# **City of Santa Clara**

**Development Review Hearing April 21, 2021**

159 Brookside Avenue

Public Hearing Item #2 PLN2020-14719

#### Site plan

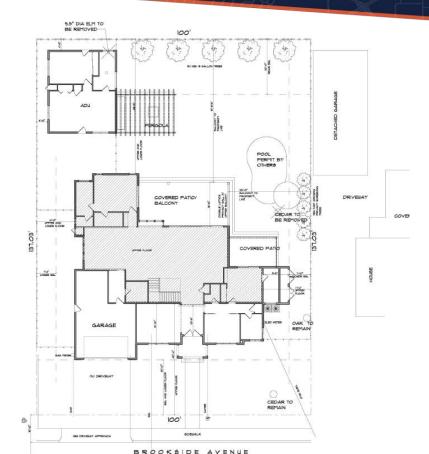
- Min Left side setback: 14'
- Min Right side setback: 5'
- Min Front setback: 20'
- Min Rear setback: 51'
- The proposed second story is not stepped back min 3' from left sides of the first-floor walls.

Redesign to provide second story wall stepped back minimum 3 feet from left sides of the first-floor walls and to make the balcony on the second floor maximum depth of four feet to allow demolition of a onestory home to construct a new two-story single-family residence located at 159 Brookside Avenue
